DrawDiff Comparison Report

Part number: DA1840189 | Job: 73a68852-0922-41cf-abf3-9311117452ac | Generated: 2026-04-28T06:02:43+00:00

VIEW_1 [MATCHED]

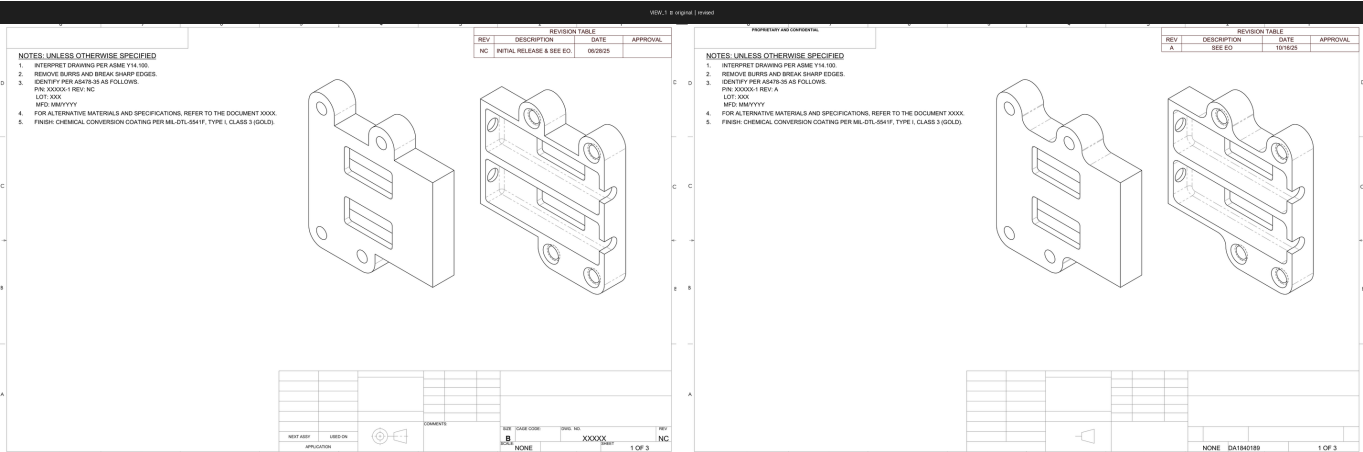
Severity	Field	Original	Revised	Conf.	Rationale
SIGNIFICANT	annotation	REV: NC	REV: A	0.95	The drawing revision level in Note 3 (P/N identification block) changed from NC to A, indicating a formal revision increment that affects part traceability.

VIEW_2 [MATCHED]

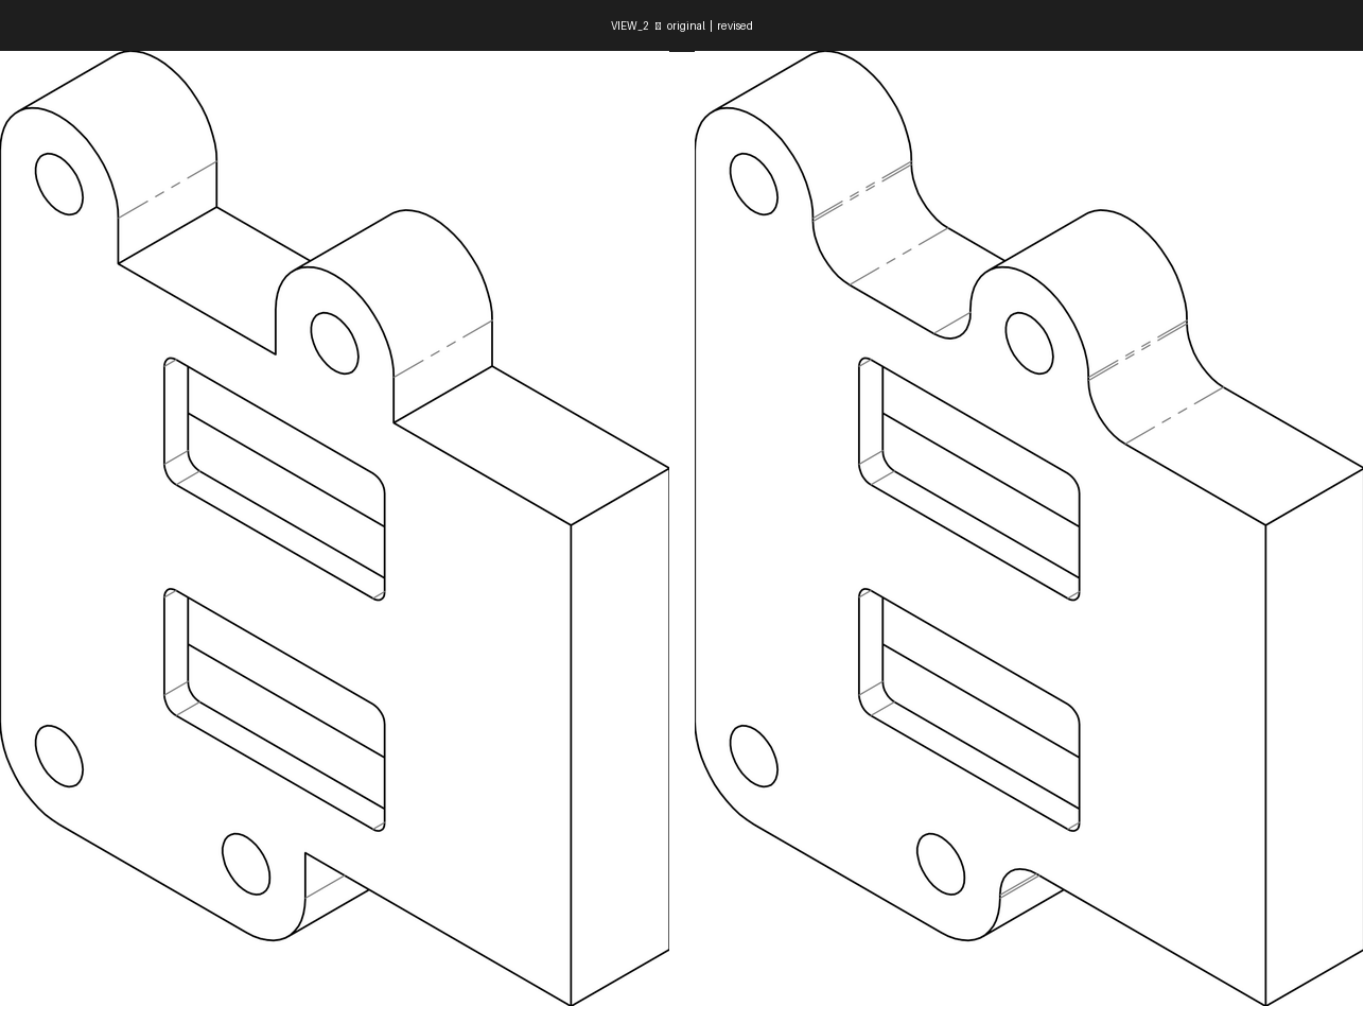
Severity	Field	Original	Revised	Conf.	Rationale
SIGNIFICANT	geometry	Upper flange/clamp arm is a	Upper flange/clamp arm shows a relief	0.78	The revised view shows a distinct geometric cutout or relief

Severity	Field	Original	Revised	Conf.	Rationale
		single solid curved profile with no cutout or relief between the two curved bosses	cutout or slot between the two curved bosses, creating a thinner web/bridge section visible in the isometric view		feature between the two upper curved mounting bosses that is absent in the original, indicating a material removal change that could affect structural stiffness and clamping function of the upper flange.

VIEW_3 [MATCHED]

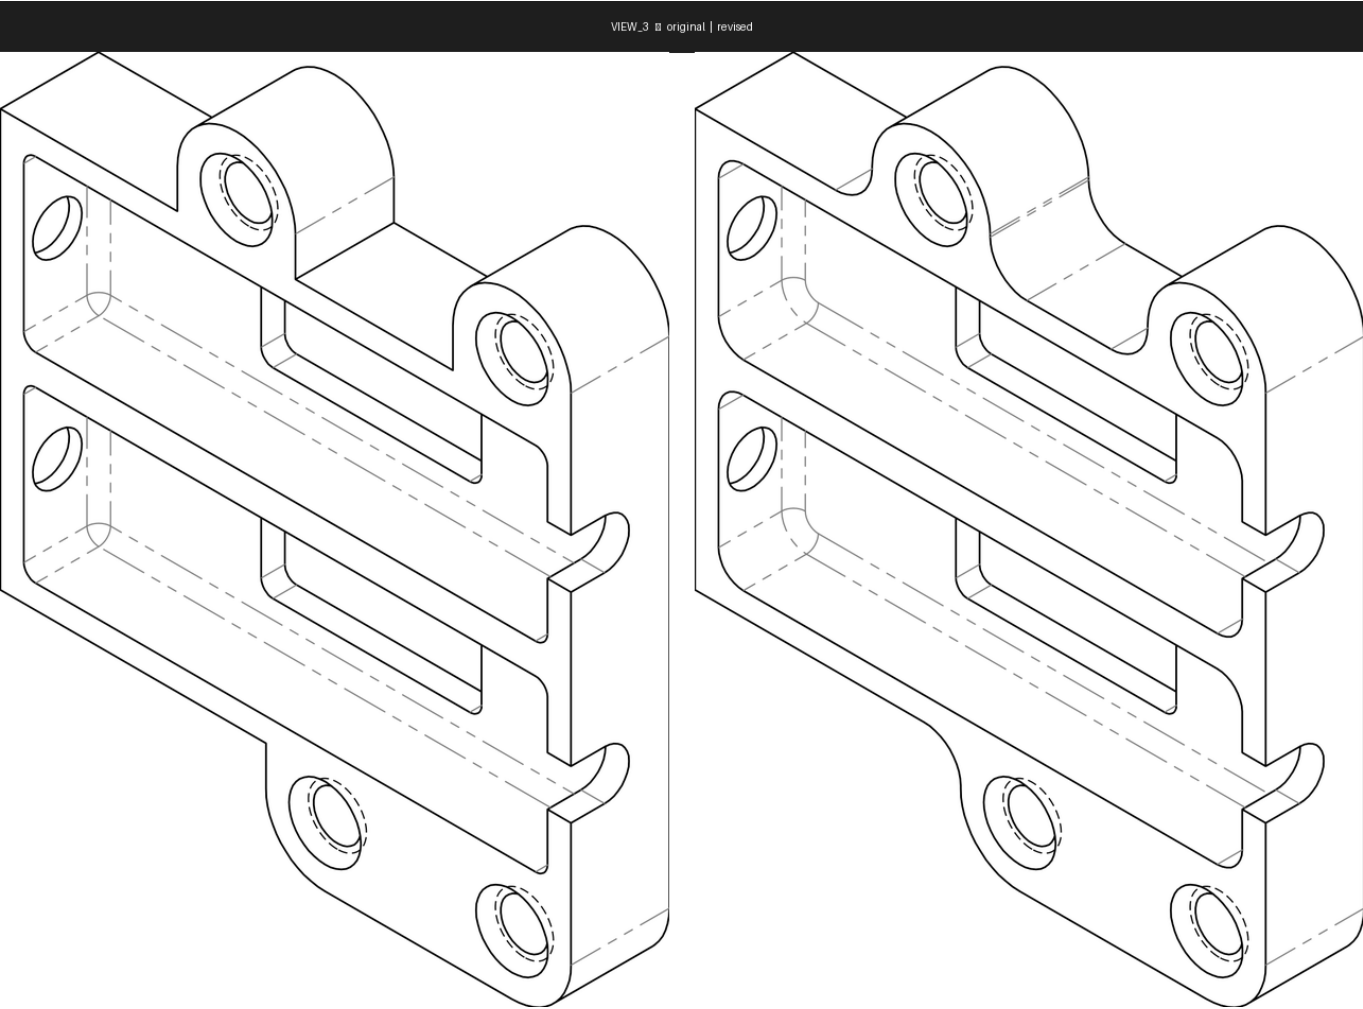
Severity	Field	Original	Revised	Conf.	Rationale
SIGNIFICANT	geometry	Sharp interior corners at the left-side vertical edges of the upper and lower recessed pocket openings (left face)	Filleted/radiused interior corners at the left-side vertical edges of the upper and lower recessed pocket openings (left face)	0.75	The revised view shows curved/filleted transitions at the interior corners of the left-face pocket openings where the original had sharp right-angle corners, indicating a geometry change that affects stress concentration and potentially toolpath/manufacturing requirements.

SIDE [MATCHED]

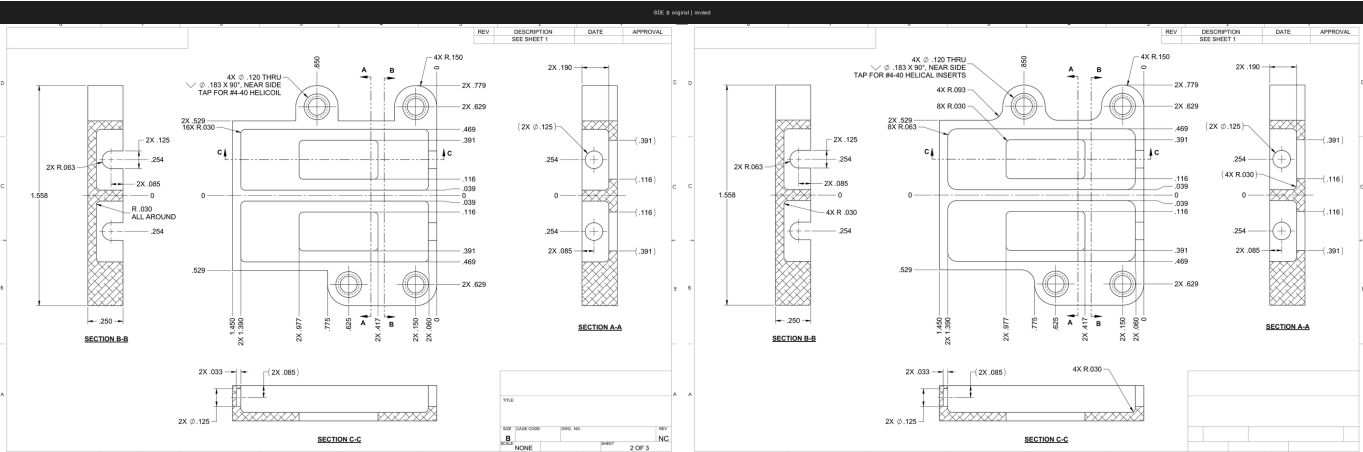
Severity	Field	Original	Revised	Conf.	Rationale
SIGNIFICANT	geometry	Rectangular pocket corners in main view appear with single radius callout grouping	Pocket corners now show separate R.093 (boss area) and R.063 (pocket area) callouts with revised quantities	0.75	The radius callout structure across the main view was reorganized with new distinct radius values (R.093) added and existing radius quantities redistributed, suggesting geometric changes or clarification of corner radii on different features.
MINOR	note	TAP FOR #4-40 HELICOIL	TAP FOR #4-40 HELICAL INSERTS	0.92	[deduped across views] The insert type callout wording changed from 'HELICOIL' (brand name) to 'HELICAL INSERTS' (generic term), which is a documentation/ nomenclature change that does not affect the thread specification or hole geometry.

SIDE [MATCHED]

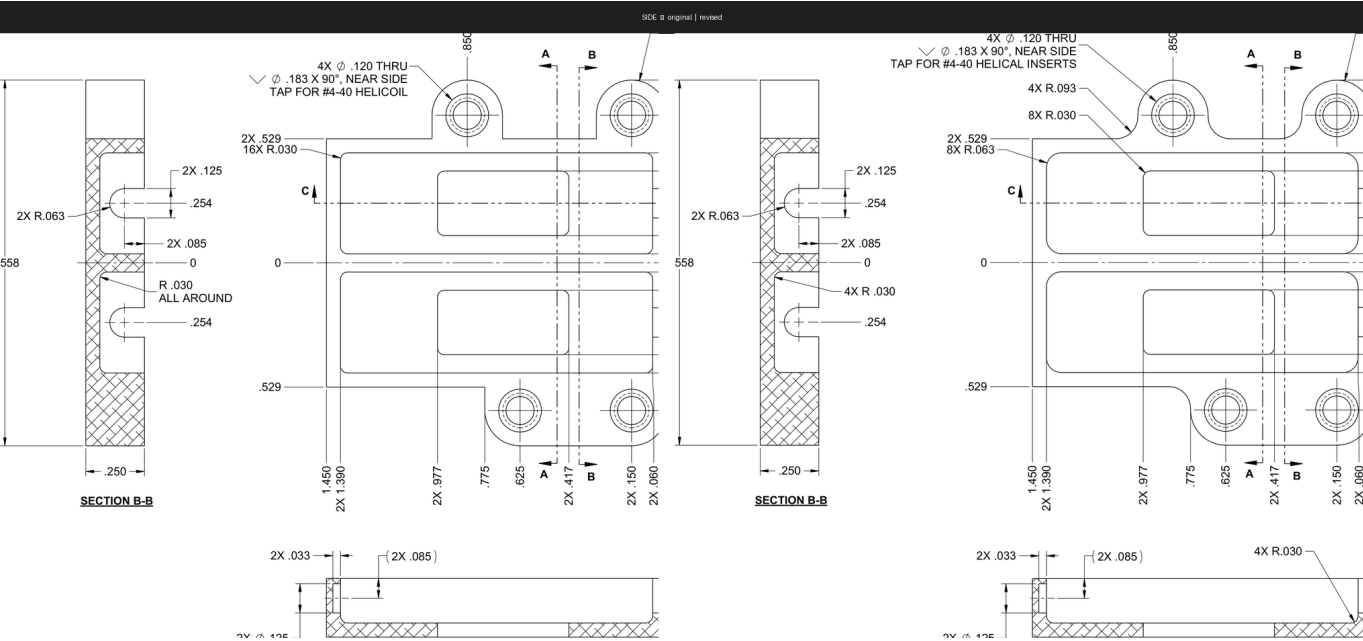
Severity	Field	Original	Revised	Conf.	Rationale
SIGNIFICANT	annotation	16X R.030	8X R.030	0.90	[deduped across views] The count of R.030 radii on the rectangular pocket corners changed from 16X to 8X, indicating either a reduction in the number of radiused corners or a re-attribution of some radii to a different callout, which affects machining requirements.

SIDE SIDE [MATCHED]

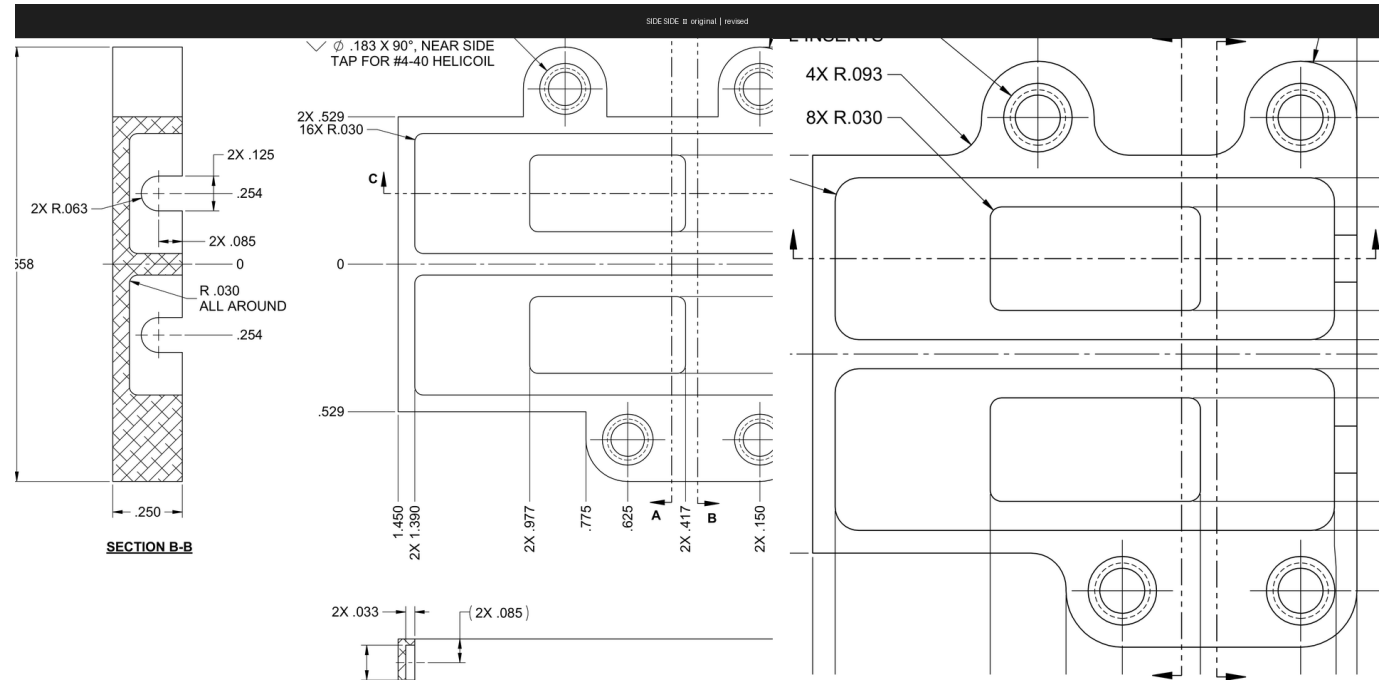
Severity	Field	Original	Revised	Conf.	Rationale
SIGNIFICANT	geometry	Rectangular pockets with uniform R.030 corners (16 total)	Rectangular pockets with mixed radii: 4X R.093 outer corners and 8X R.030 inner corners	0.78	The pocket geometry appears to have been revised to use larger radii on outer corners and smaller radii on inner corners, changing the machining profile and potentially the fit of mating components.

SIDE SIDE [MATCHED]

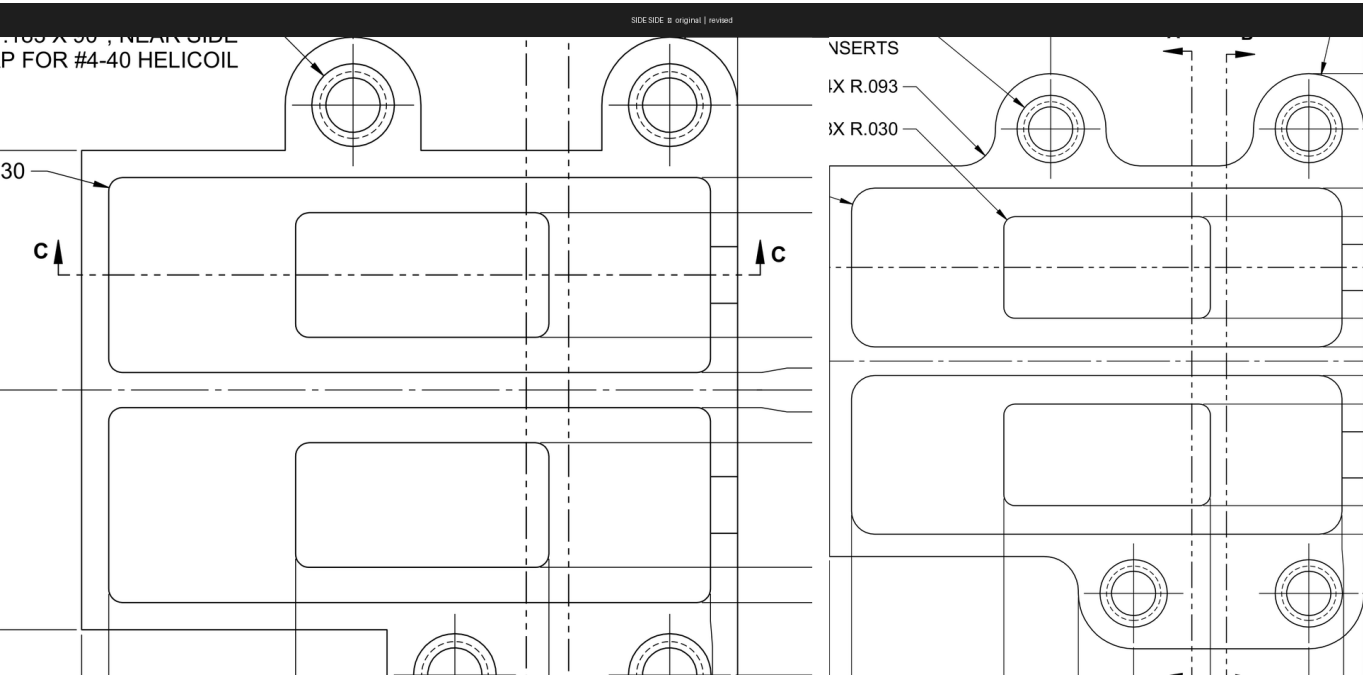
Severity	Field	Original	Revised	Conf.	Rationale
SIGNIFICANT	callout	—	4X R.093	0.82	A new radius callout of 4X R.093 has been added in the revised drawing, specifying fillet radii on the bracket features that were not explicitly called out before.
SIGNIFICANT	geometry	Sharp/ square upper-left corner on bracket body	Radiused/filleted upper-left corner on bracket body	0.72	The upper-left corner of the bracket body outline appears to have changed from a sharp corner to a visible radius, consistent with the new R.093 or R.030 callouts.
UNCERTAIN*	annotation	Section line labeled C-C with arrows on both sides	Section line C-C arrows appear repositioned/restyled; additional section cut line (A-B) visible at top	0.60	The section cutting plane indicators appear to have been adjusted; the C-C section line dashes on the left side are shorter/repositioned, and new section arrows (A, B) are visible at the top of the revised view. [possible match: VIEW_1]

SIDE [MATCHED]

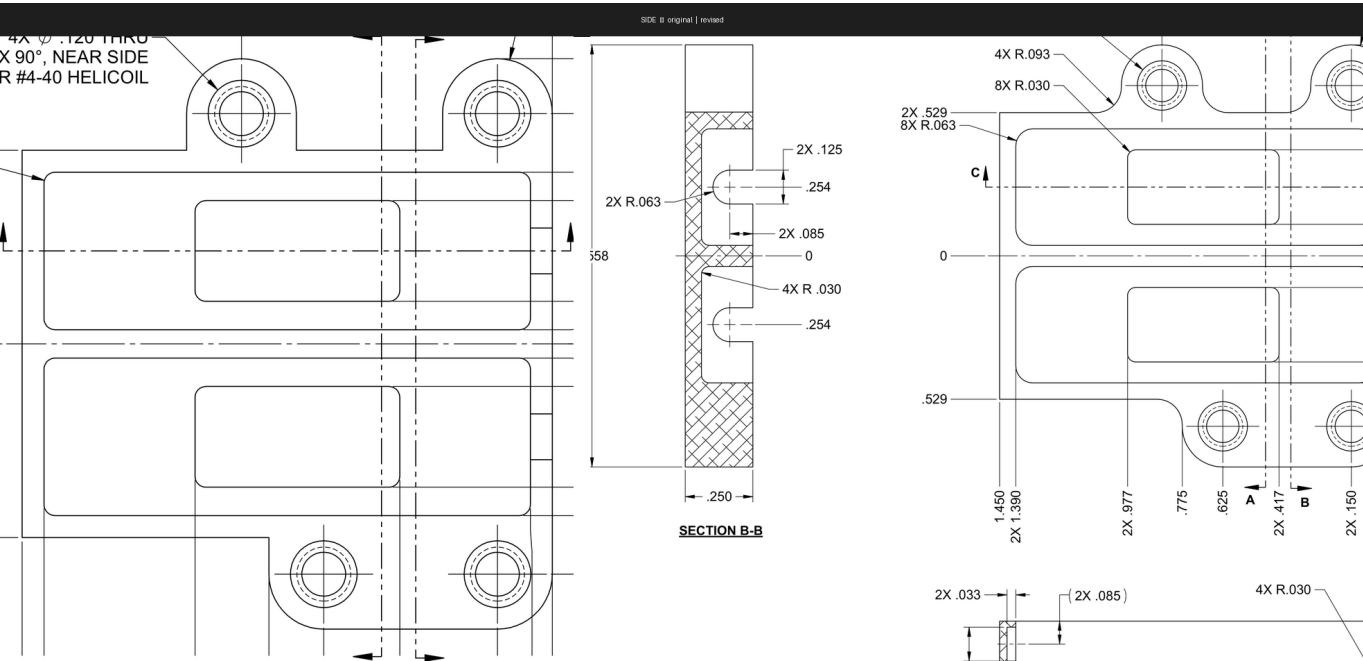
Severity	Field	Original	Revised	Conf.	Rationale
SIGNIFICANT	annotation	—	SECTION B-B with cross-section detail showing 2X .125, .254, 2X .085, 0, 4X R.030, .254, 2X R.063, .558, .250	0.85	A new Section B-B cross-section view has been added to the revised drawing, providing internal wall profile dimensions and radii not previously shown, which defines manufacturing geometry for the pocket walls.

SIDE [MATCHED]

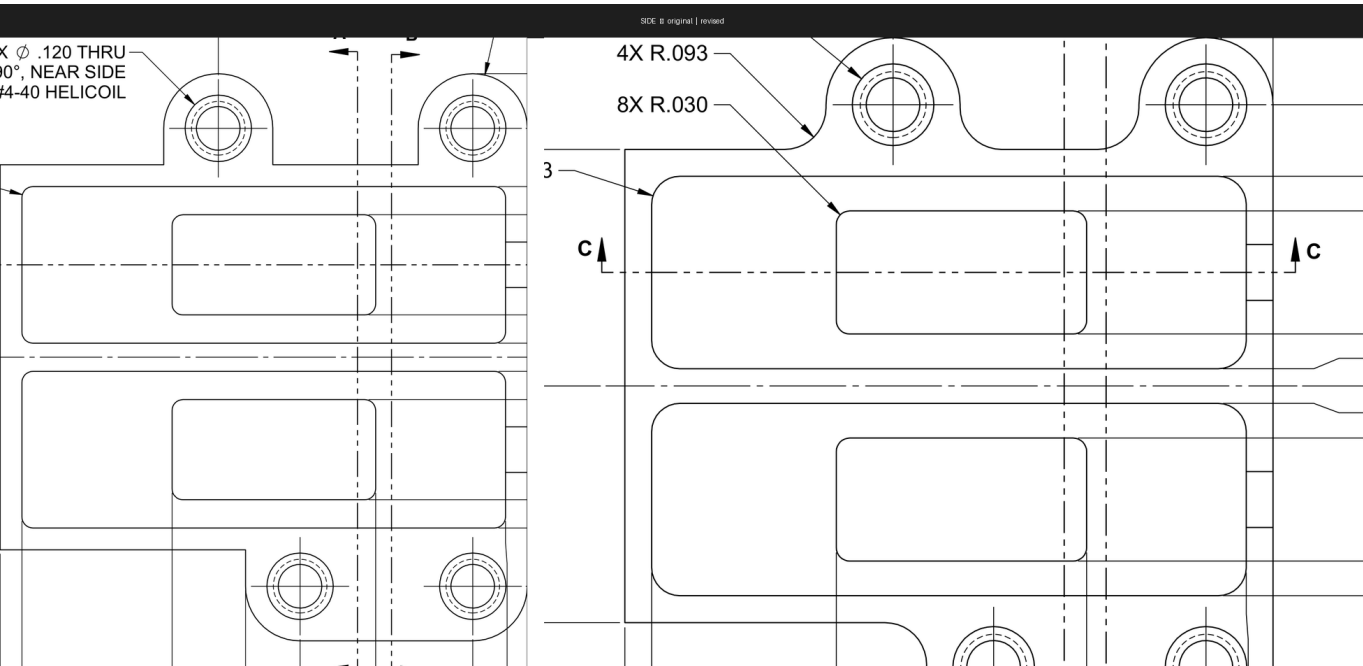
Severity	Field	Original	Revised	Conf.	Rationale
SIGNIFICANT	annotation	—	4X R.093	0.85	A new radius callout of 4X R.093 has been added to the revised view, specifying the corner radii on the

Severity	Field	Original	Revised	Conf.	Rationale
					mounting boss features, which was not present in the original.
SIGNIFICANT	geometry	Sharp or unspecified corners on rectangular pockets and outer profile	Rounded corners explicitly shown with R.093 and R.030 radii	0.75	The revised view shows clearly radiused corners on the pocket and outer profile features with explicit callouts, whereas the original did not annotate or clearly depict these radii, representing a geometric clarification or change that affects machining.
